CONSIDERATION OF AND/OR ANY APPROPRIATE ACTION ON PANORAMA STREET PRELIMINARY PLAT, SITUATED IN THE PHILLIP ANDERSON SURVEY, ABSTRACT NO. 10 CITY OF PARKER, COLLIN COUNTY, TEXAS. [MACHADO]

Re: Panorama Street
 Preliminary Plat and Engineering Plan Review

As you requested, we have reviewed the Preliminary Plat & Engineering Plans for the Panorama Street Addition prepared by LJA Engineering, Inc. These documents include a new street and is therefore considered a major subdivision under section 155.025 of subdivision ordinance.

STORM DETAILS
SD20
 DATE: JUN 2023
 DESIGN: N/A
 DRAWN: MARTINEZ
 SCALE: HORIZ: NOT TO SCALE
 VERT: NOT TO SCALE
 SHEET 36 OF 35 SHEETS

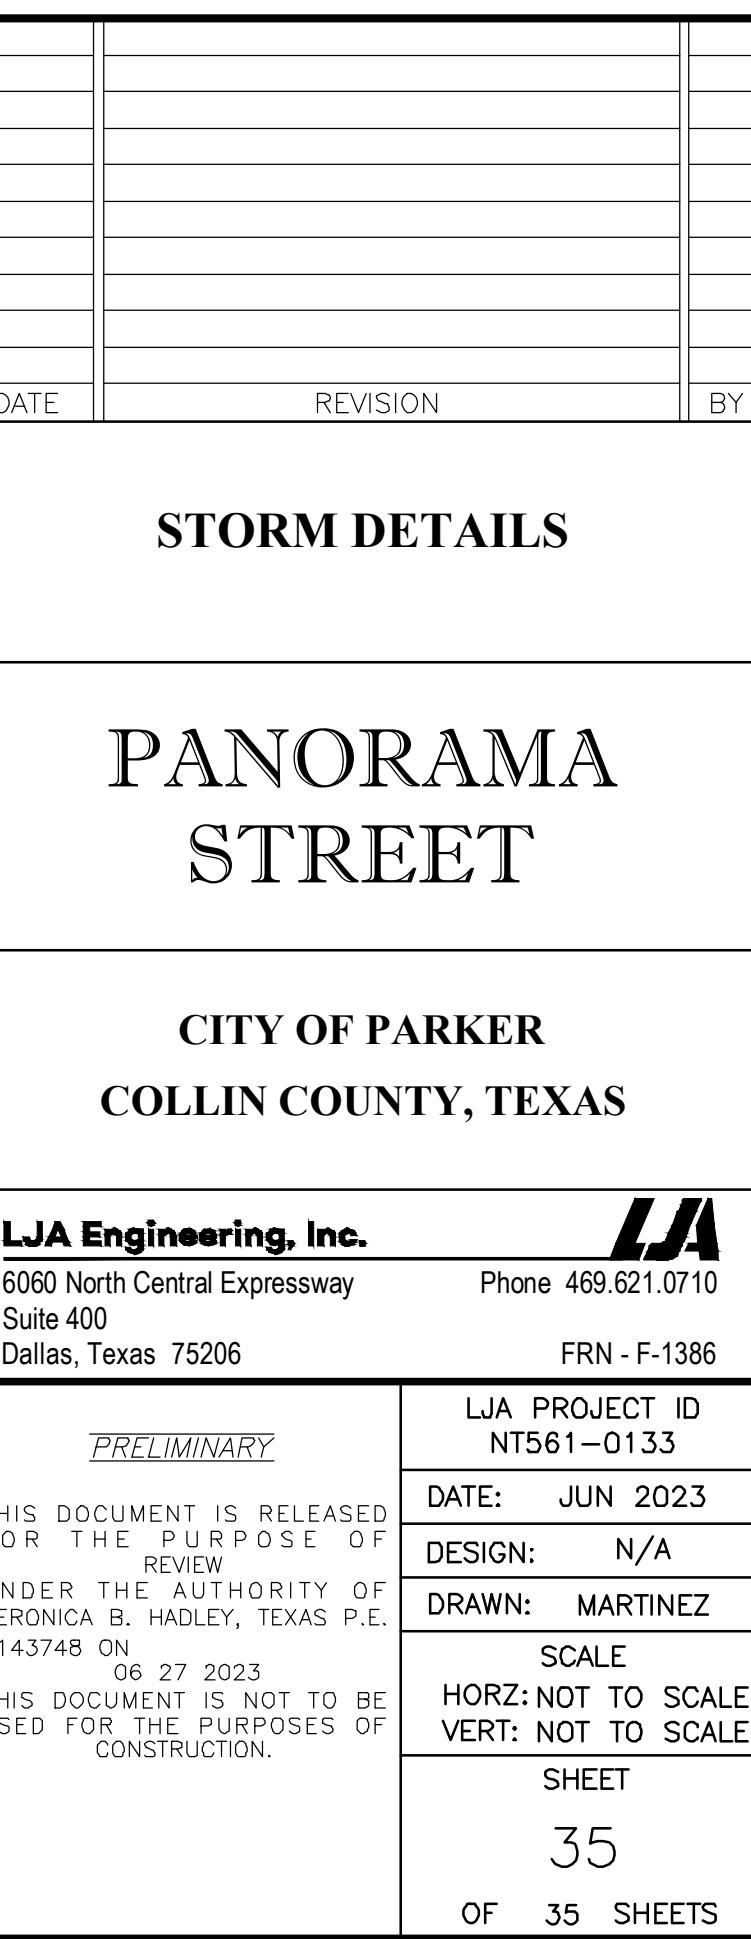
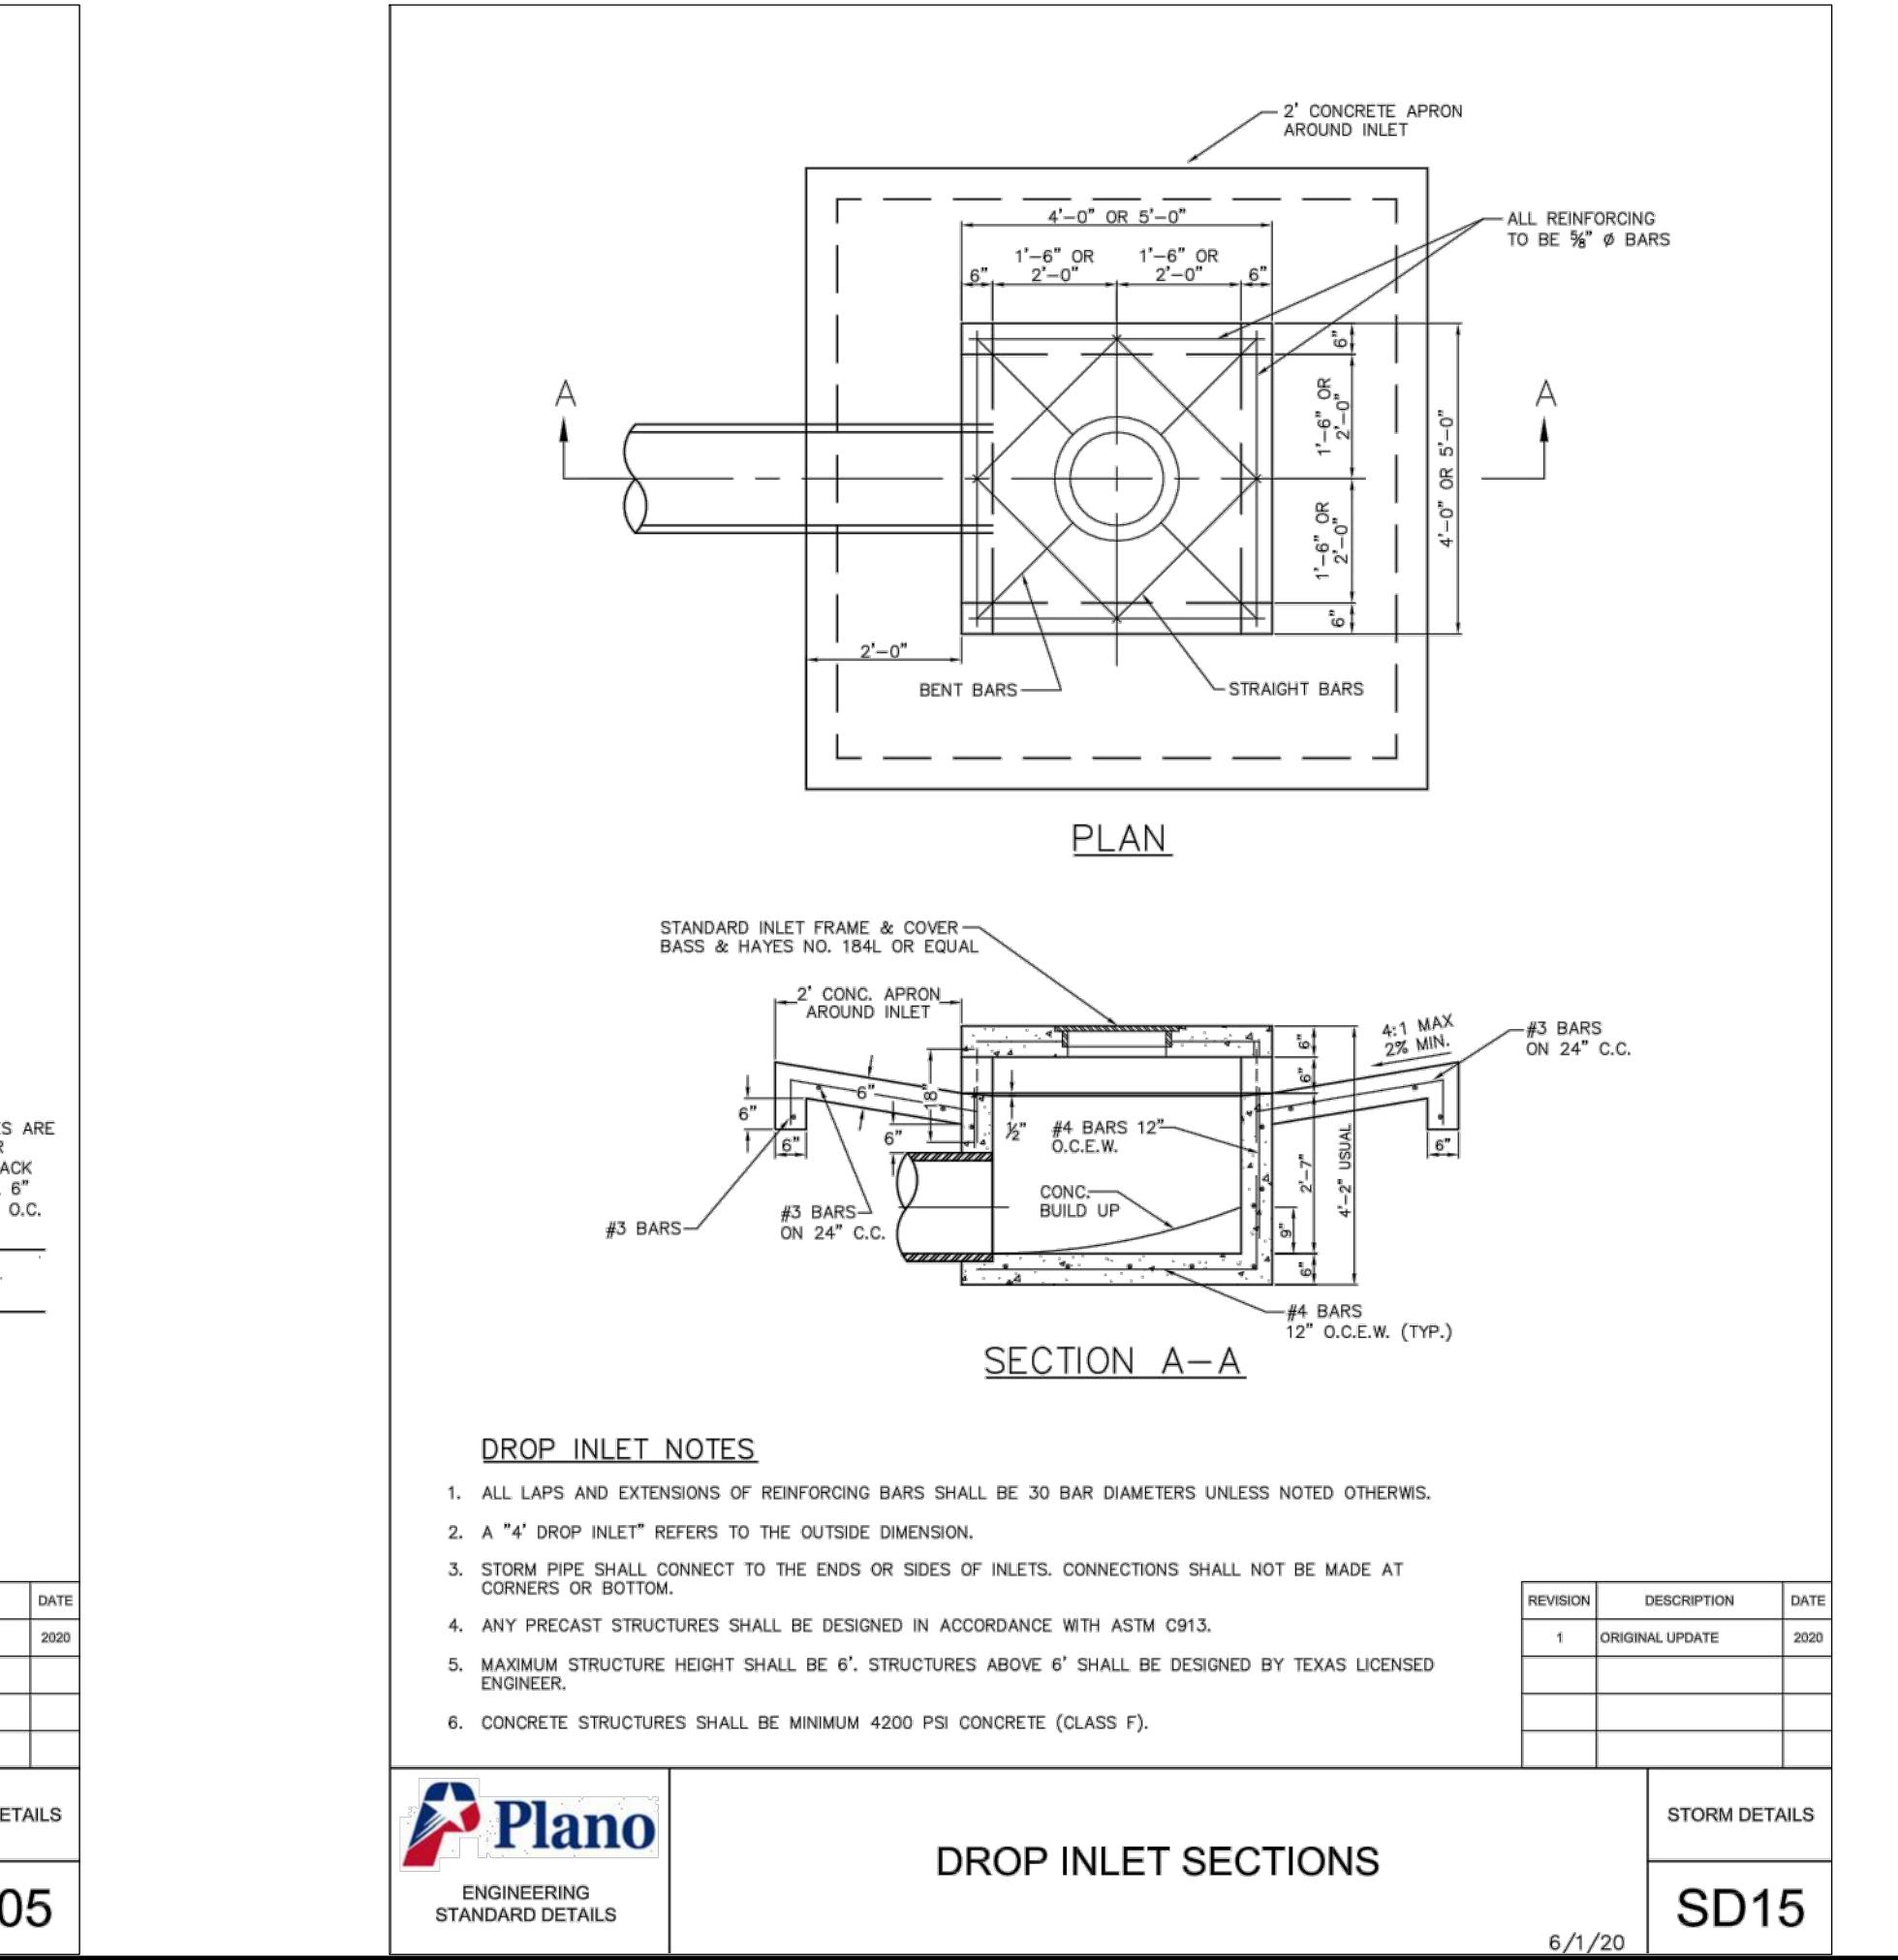
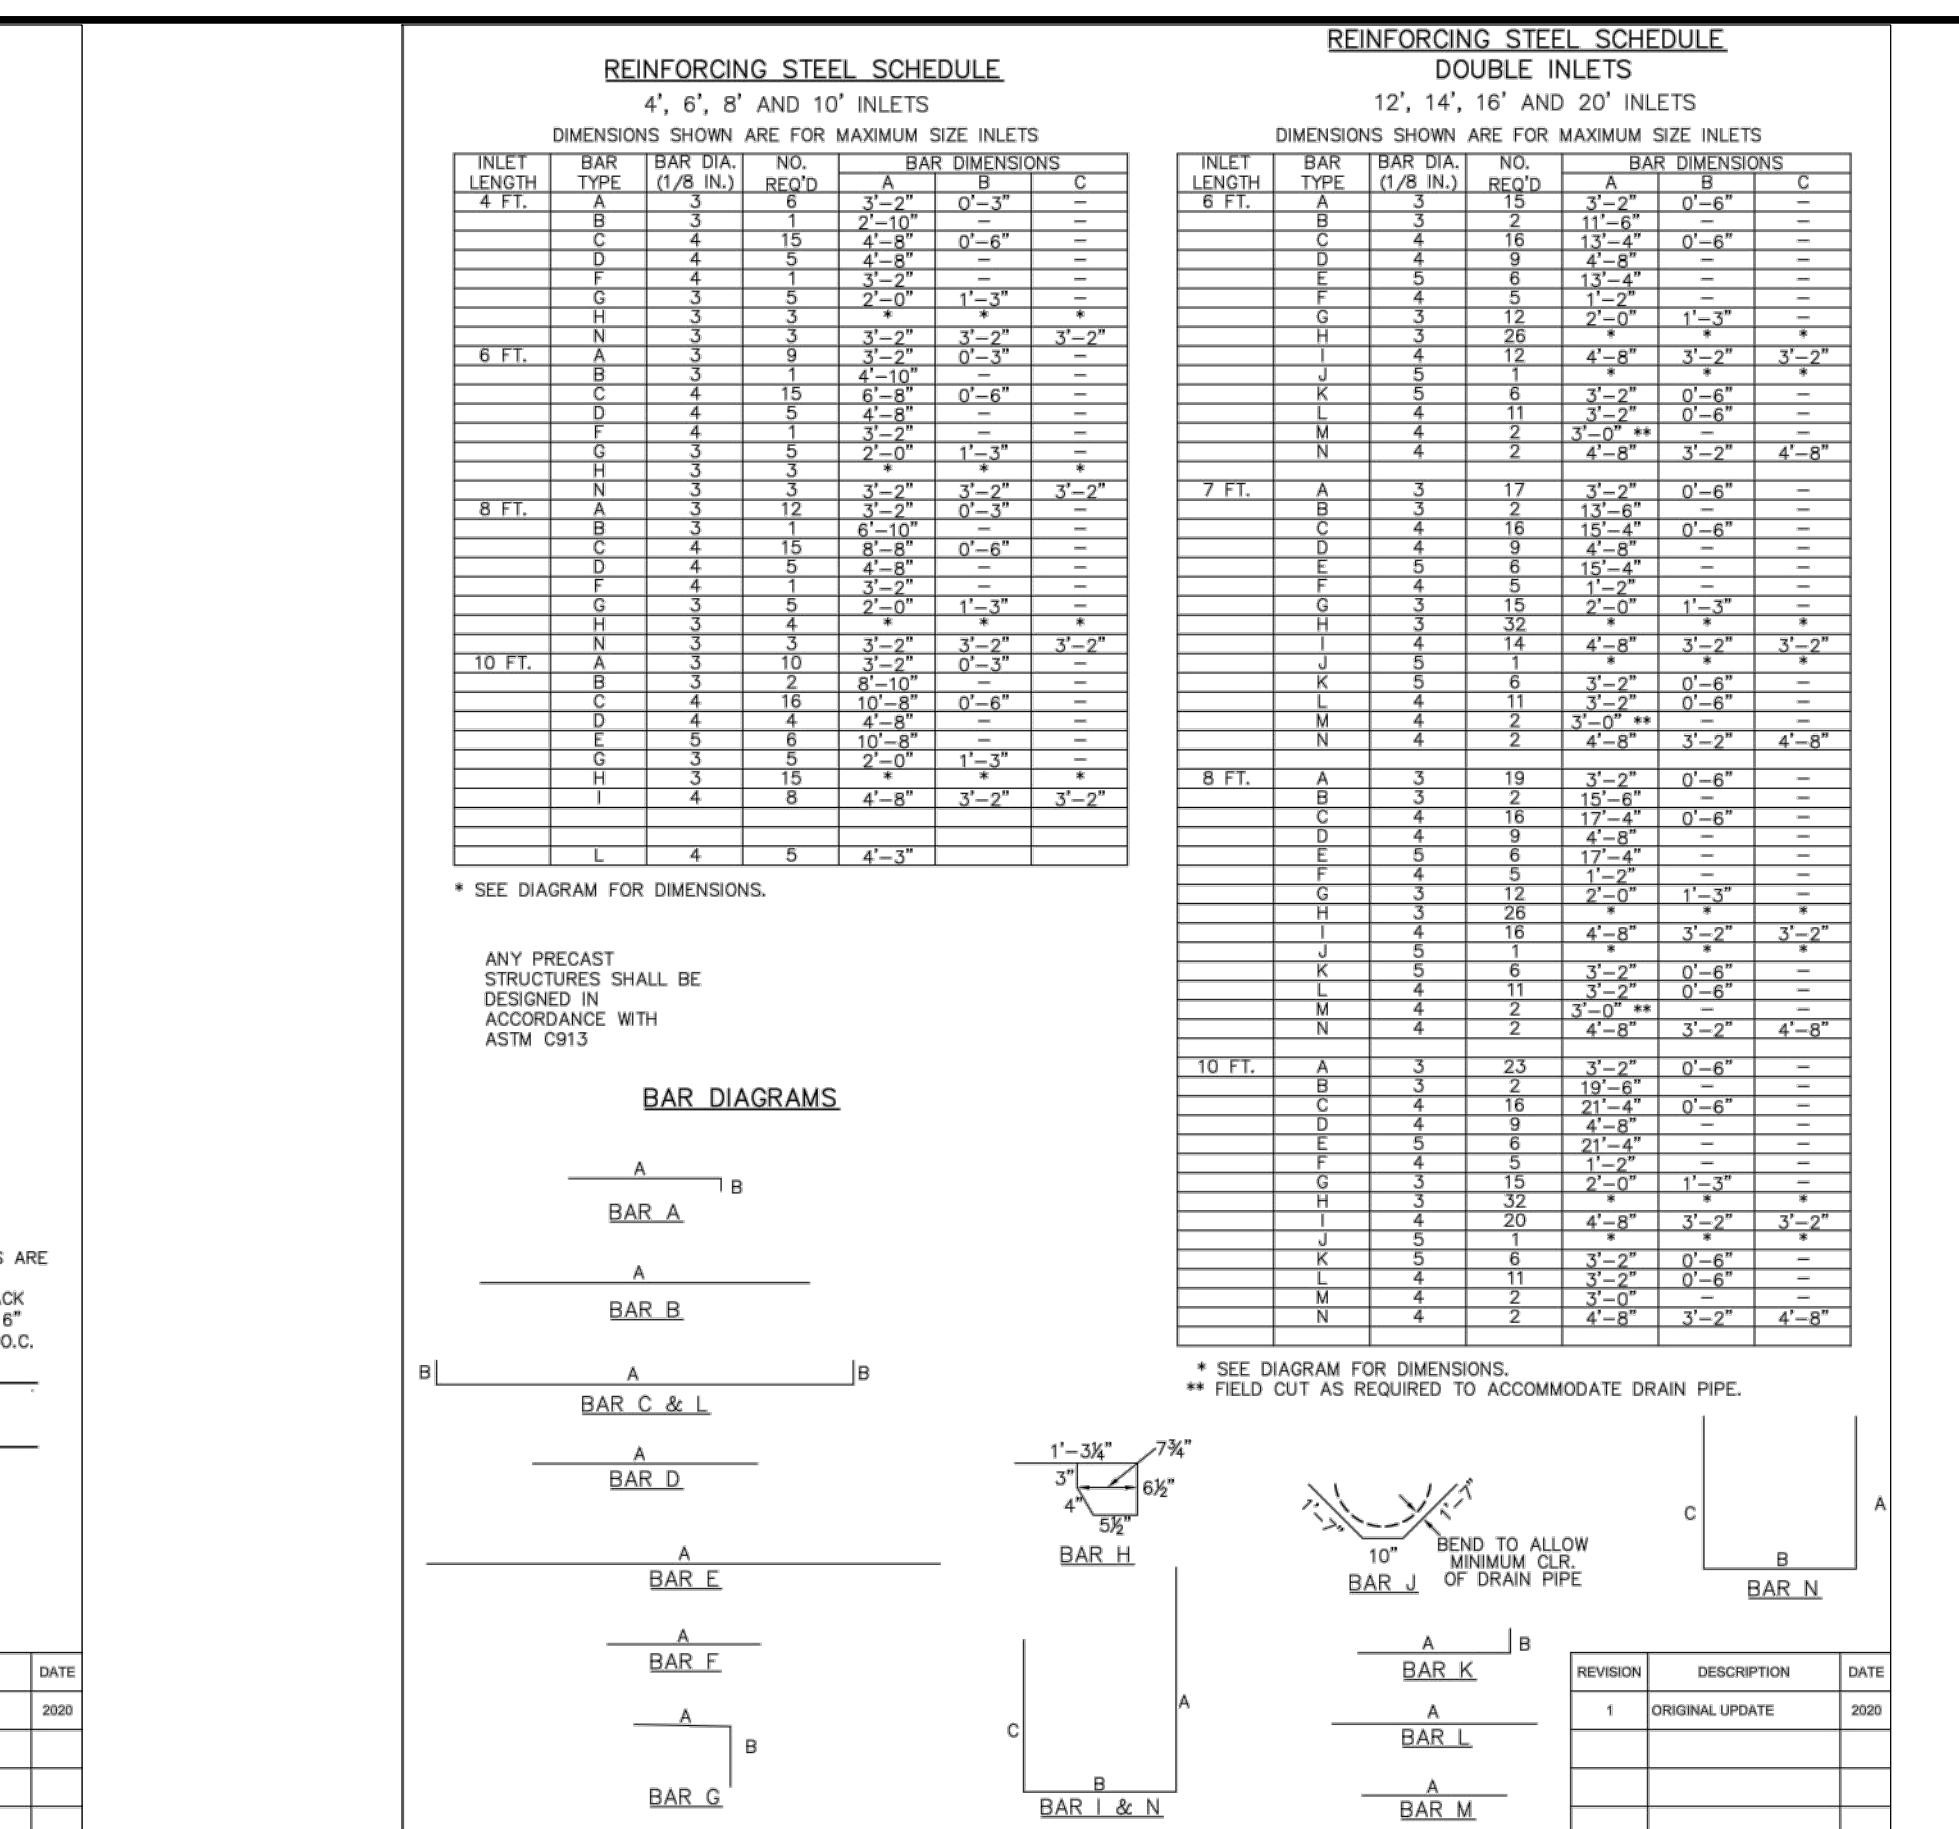
91. Sheet 36 Sloped headwall detail needs to include geotextile fabric under rock. This detail does not match what is called out in the plan set?
92. Sheet 36 Modify manhole detail to show City of Parker on manhole cover.
